Addendum No.: 1

Bid#: 24-15-2

Project Name: Meadow Lake & River Oaks New Elevated Storage Tanks

SHEET NO.
CP-001
SHEET 1 OF 1

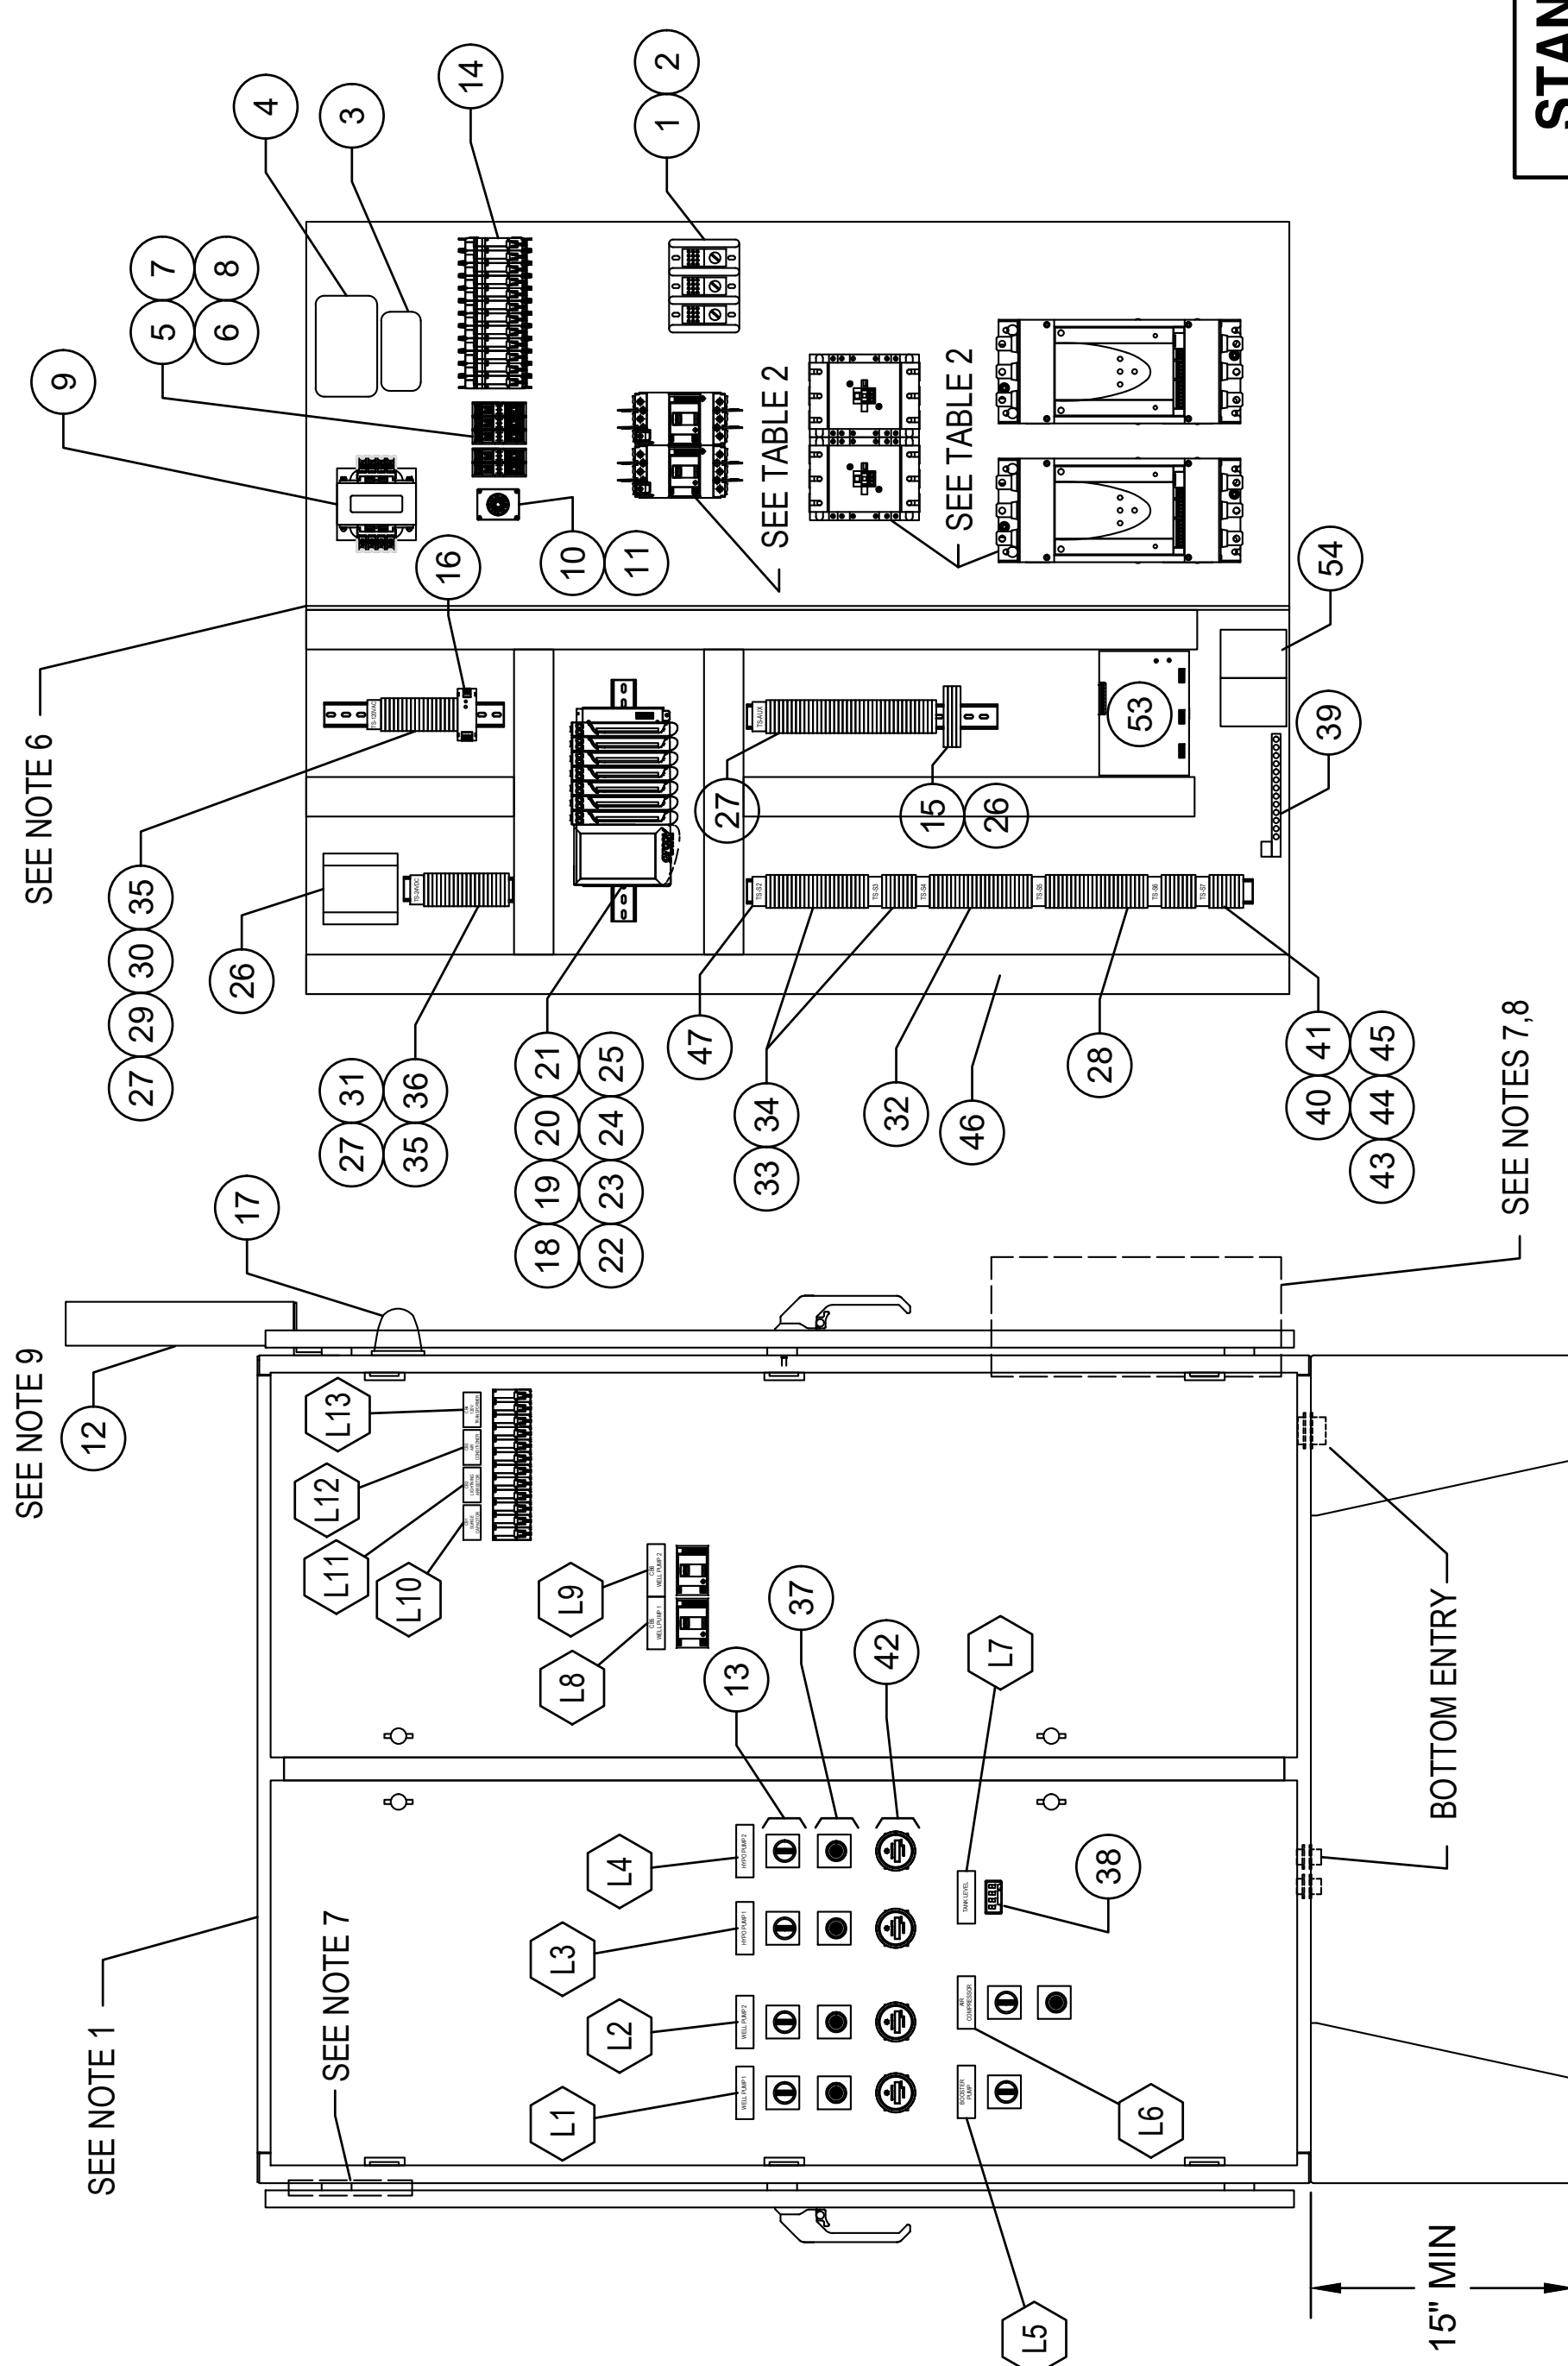
No	DESCRIPTION OF REVISION	DATE
1	UPS AND BATTERY ADDED	04/25/24

SHEET NO.
CP-002
SHEET 2 OF 2

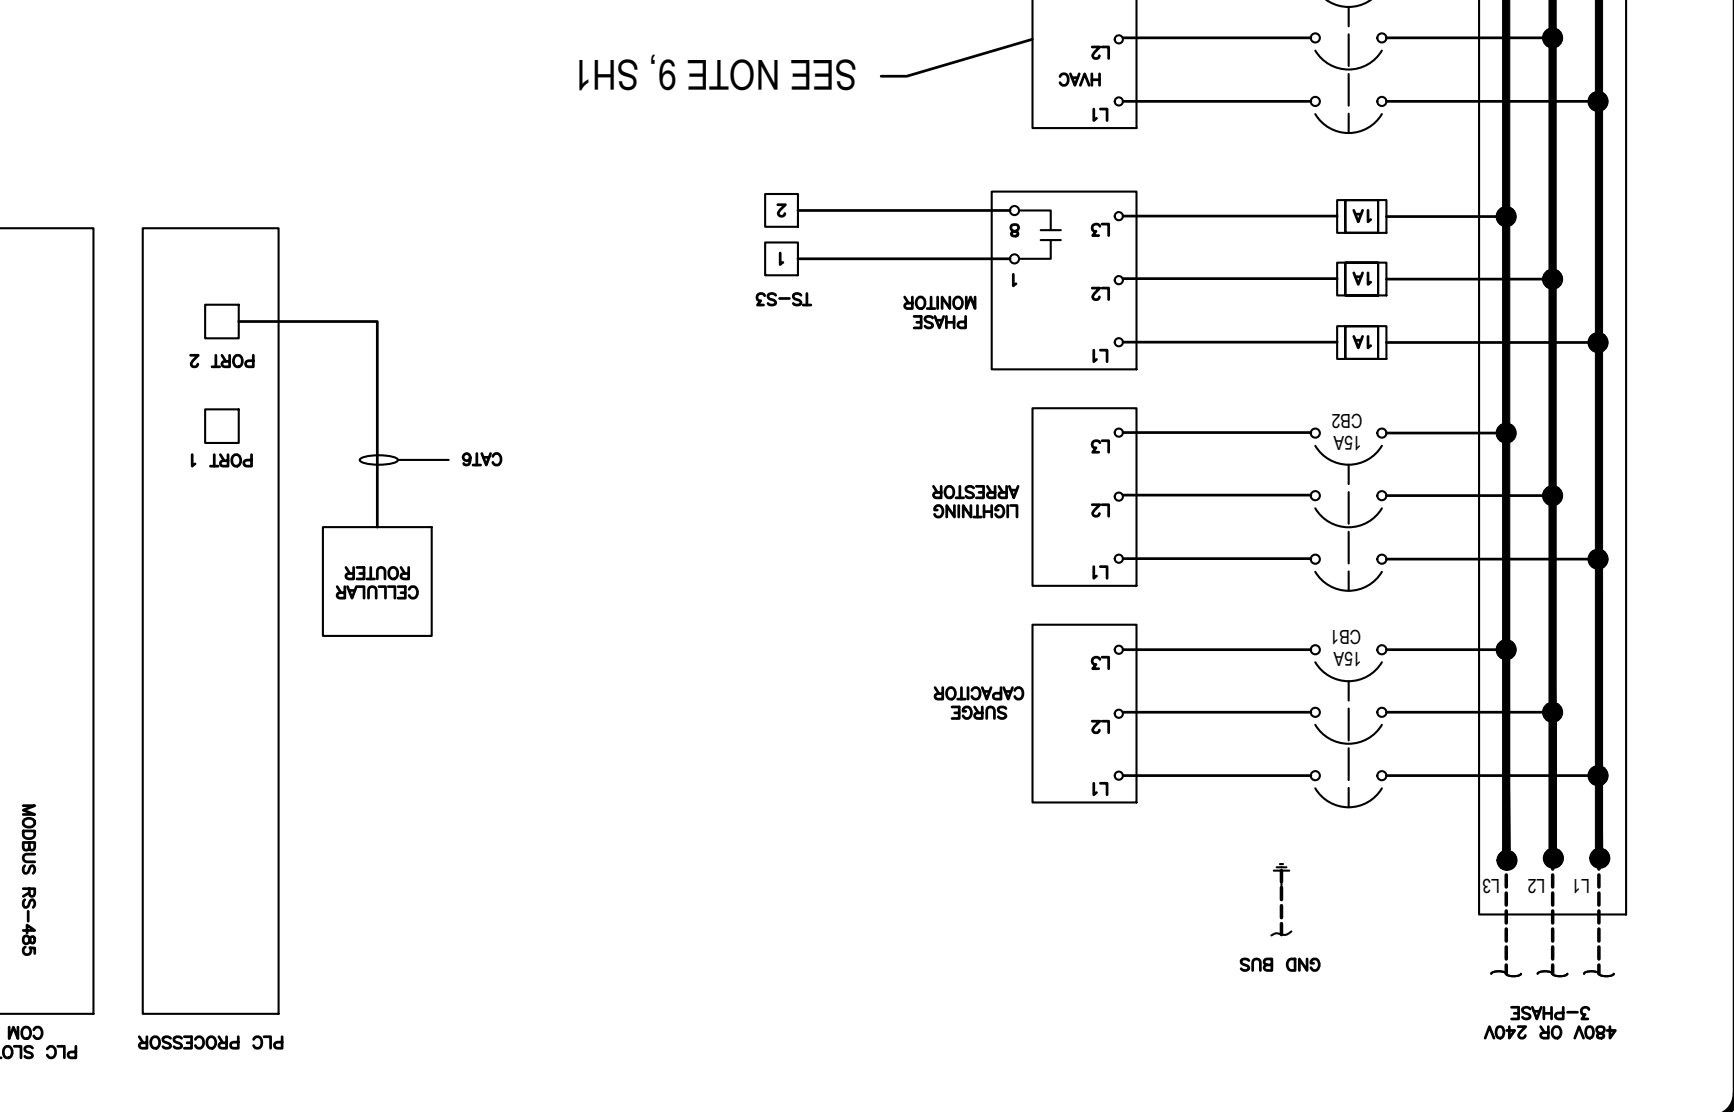
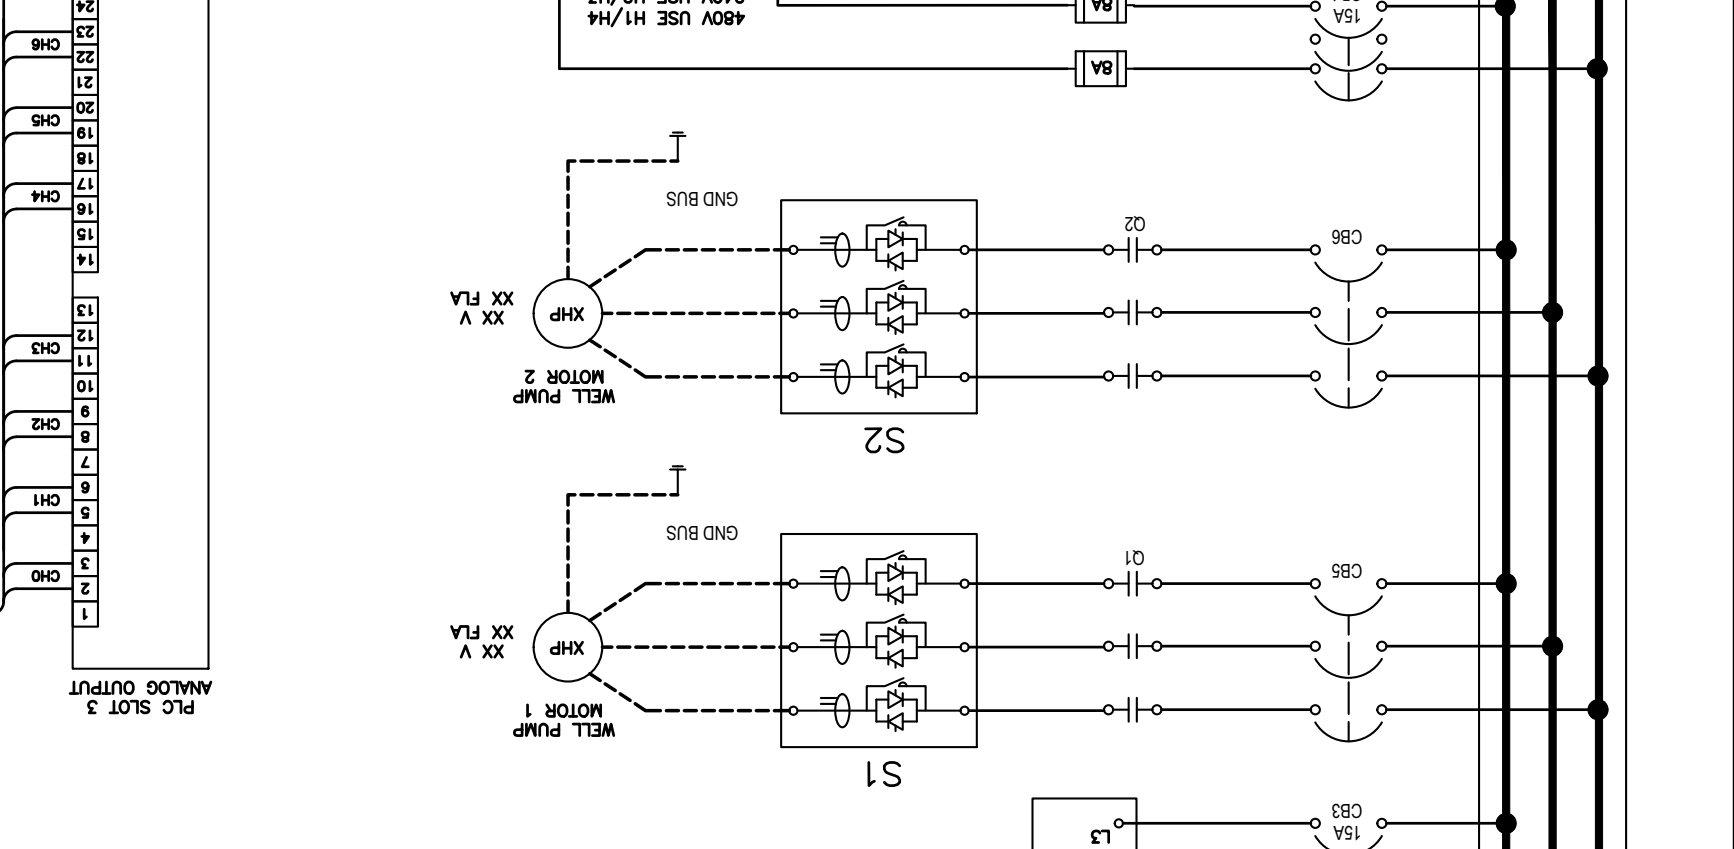
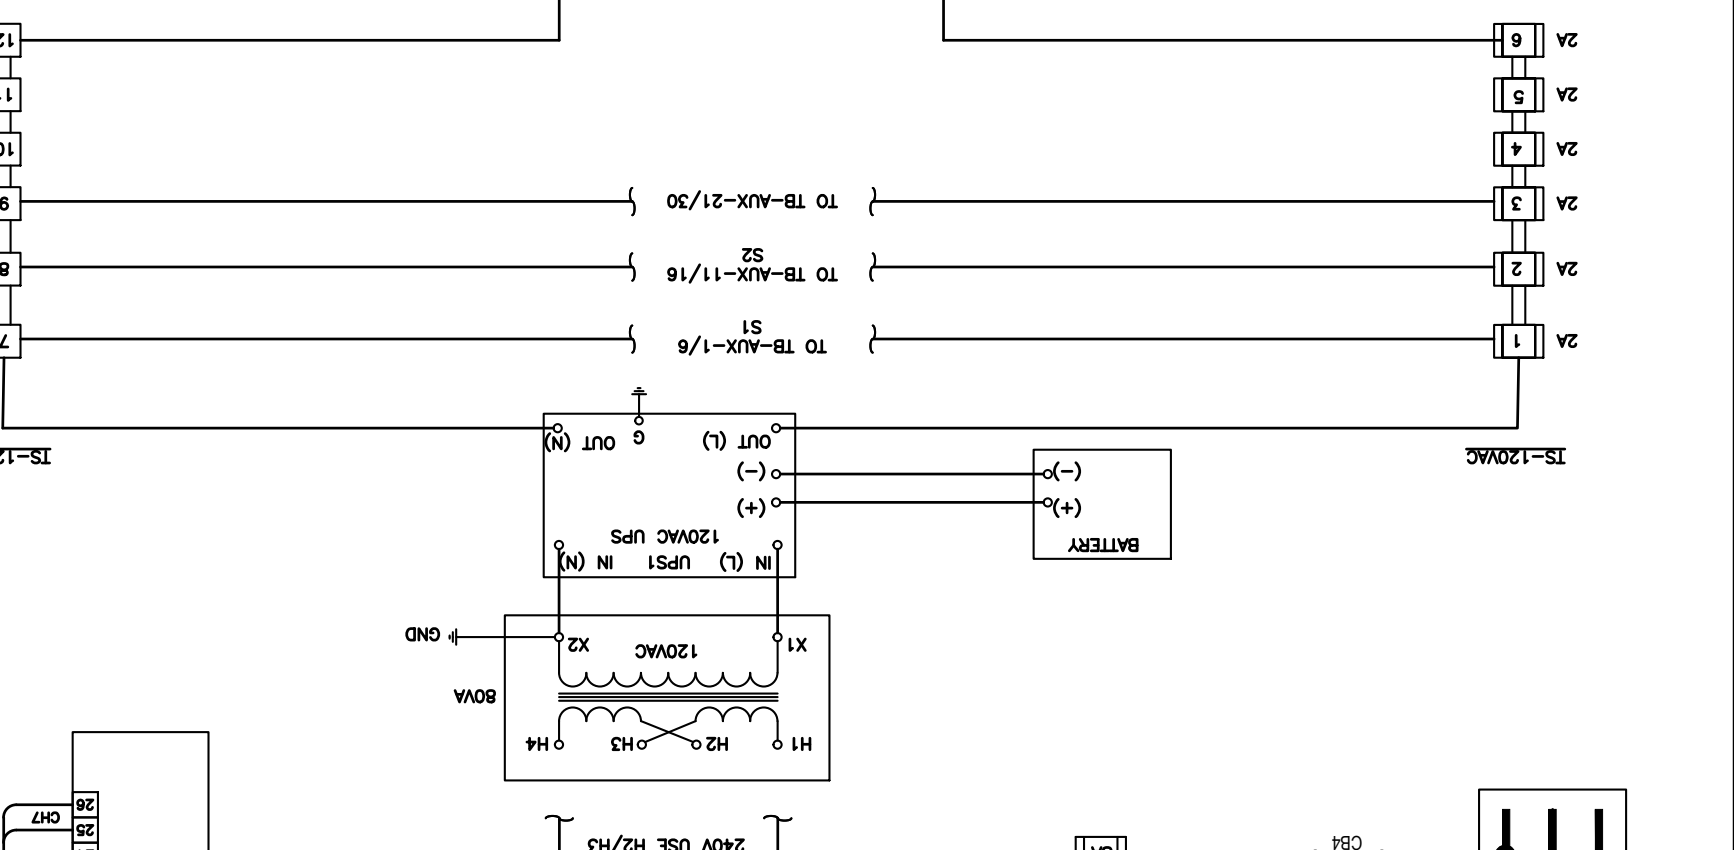
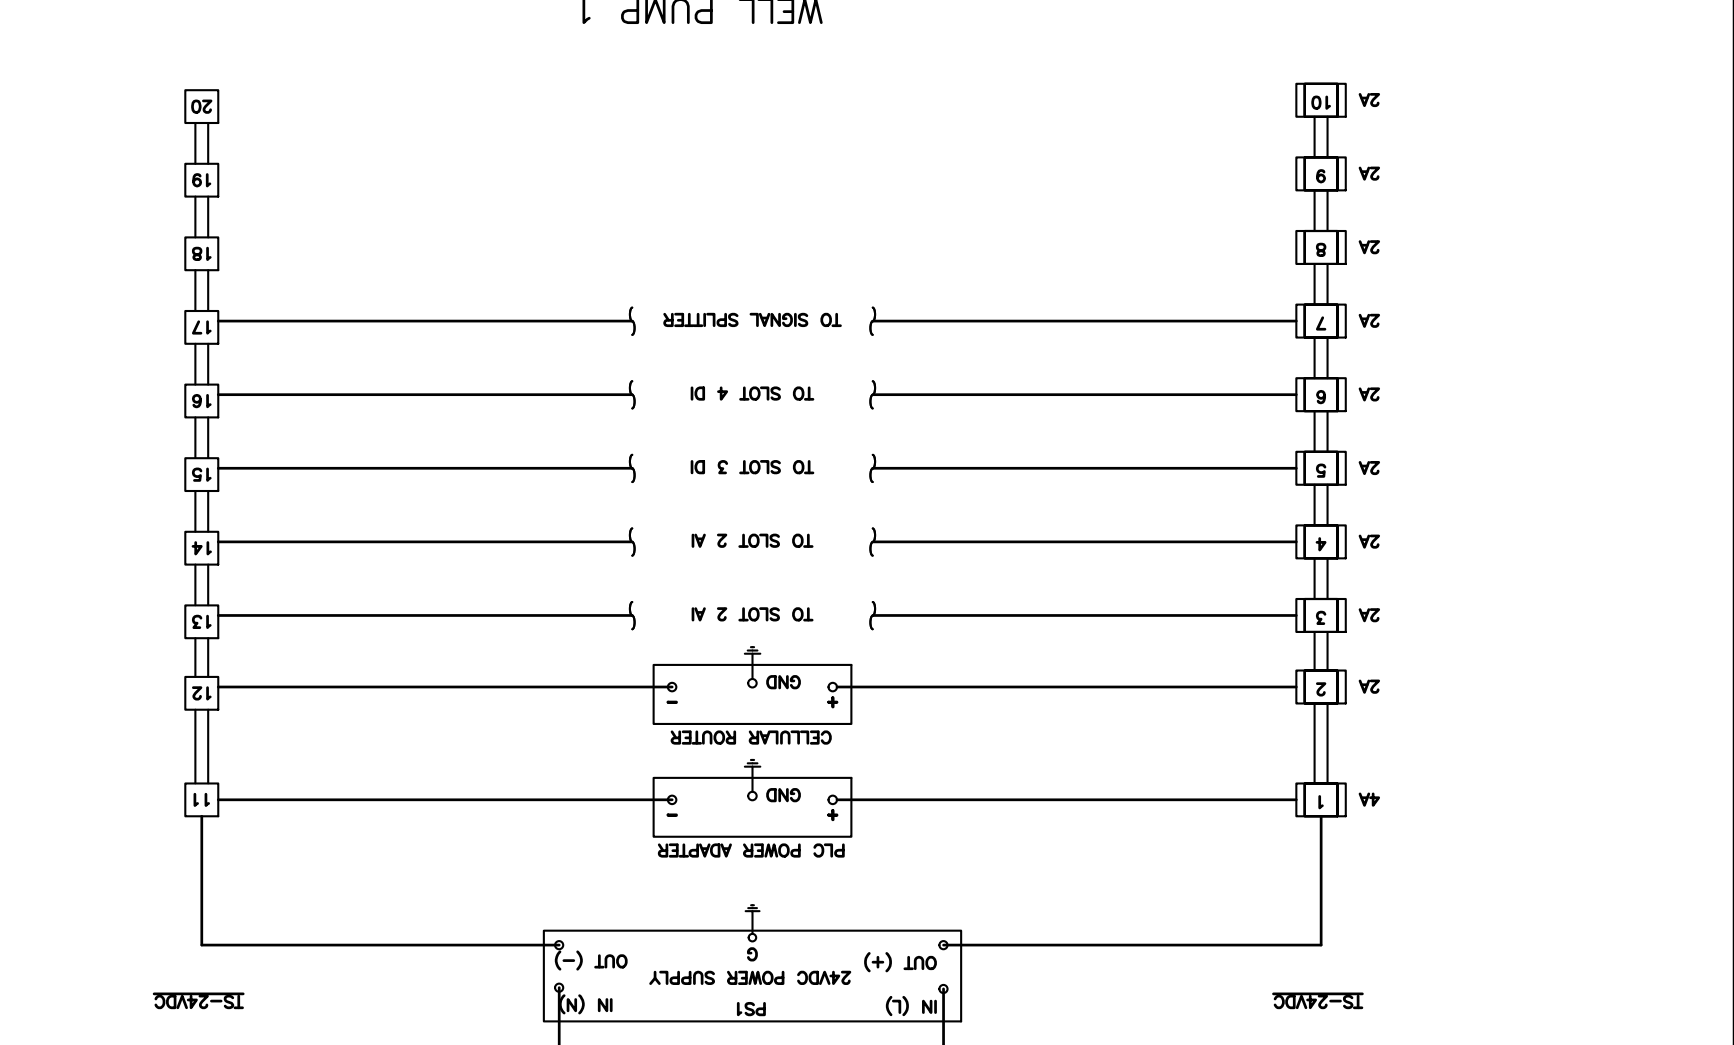
No.	DESCRIPTION OF REVISION	DATE
1	UPS AND BATTERY ADDED	04/25/24
